ADDENDUM No. 1

**AIP #3-23-0005-070-2016
Gate 3 Passenger Boarding Bridge & Holding Area**

at Bangor International Airport – Bangor, ME

Date: _____ **April 18, 2016** _____

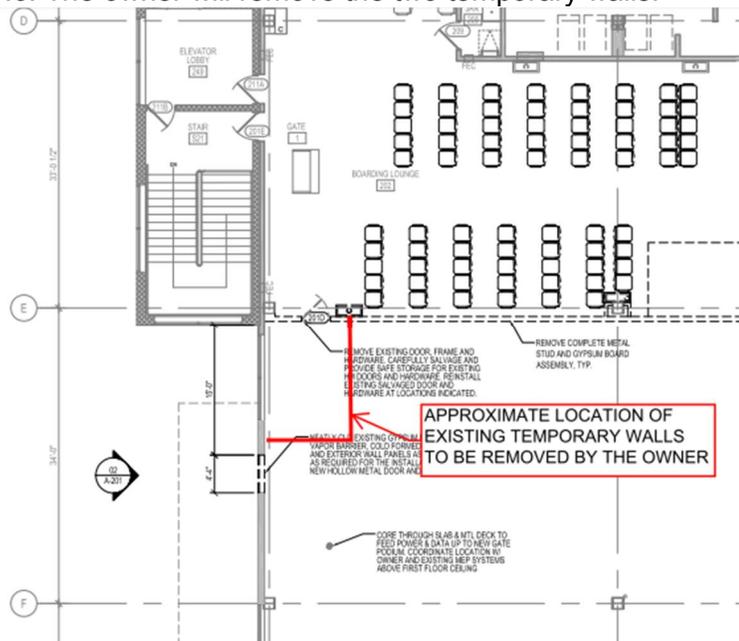
Question asked during the site walk:
Will demolition of the existing temporary police office walls (shown below) be part of the scope of this project?

Clarification/Response: No. The owner will remove the two temporary walls.

REVISE Detail 2 on Drawing No. C-200 as follows:

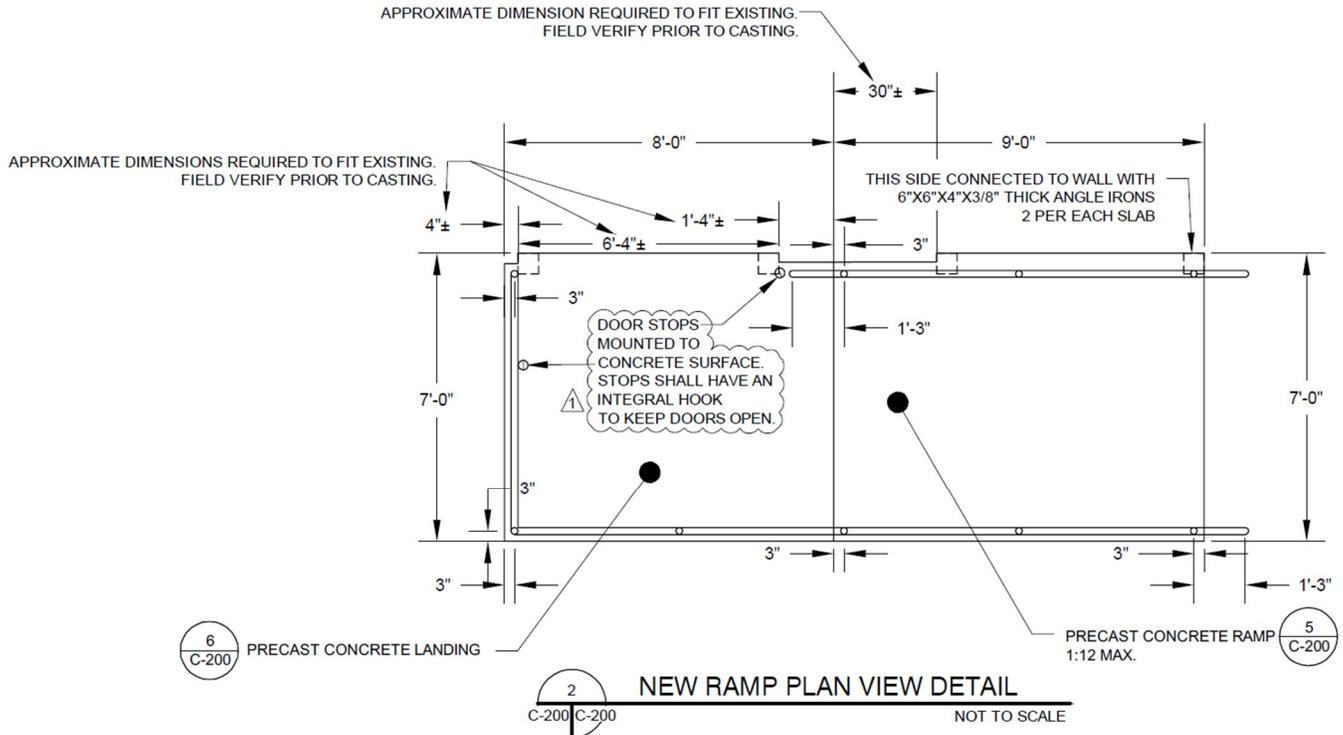
Changes to the drawing consist of adding two door stops.

REVISE the notes on Detail 6 of Drawing No. C-300 as follows:

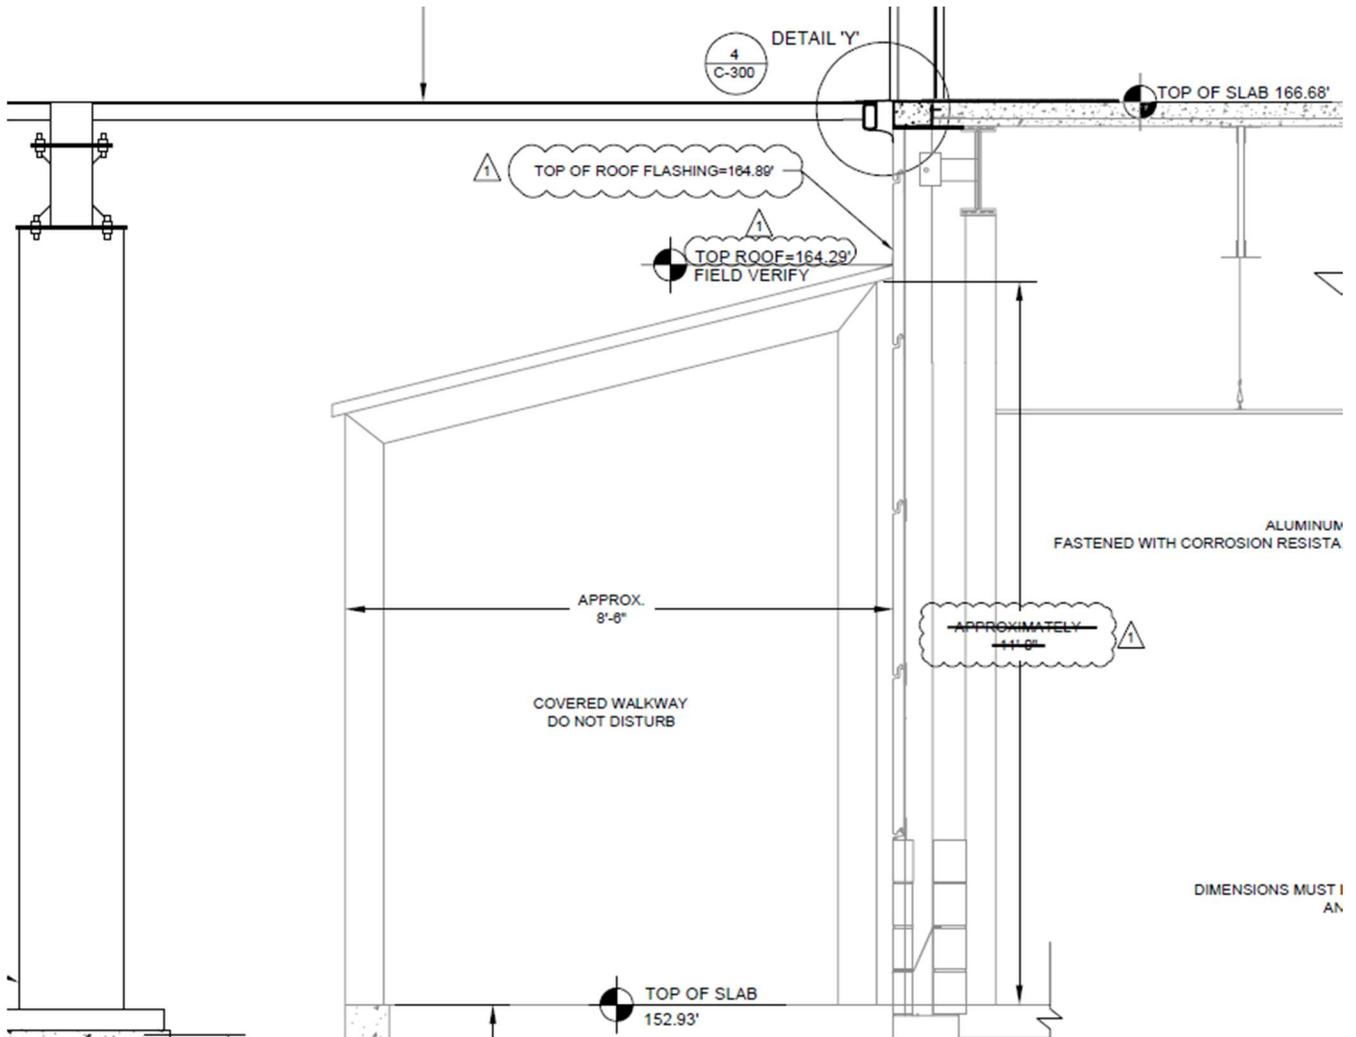
Changes/additions provide more precise information on the height of the existing covered walkway.

DOOR 220A - STRUCTURAL
DEMOLITION DETAIL AT EXTERIOR WALL
NOT TO SCALE

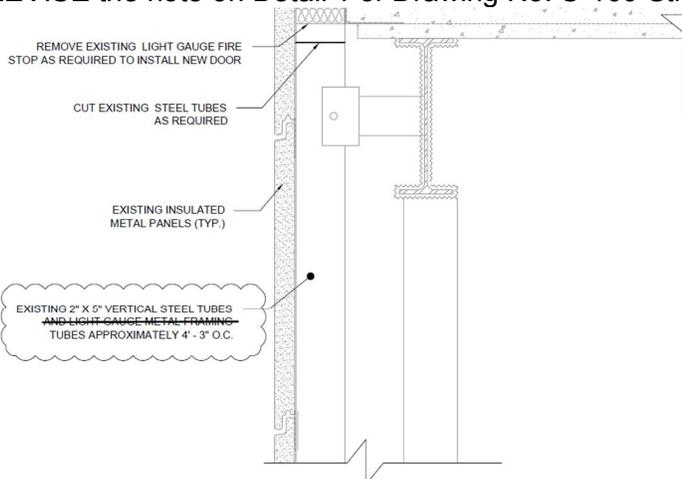
REVISE the note on Detail 1 of Drawing No. S-100 *Structural Details 1 of 2* as follows:
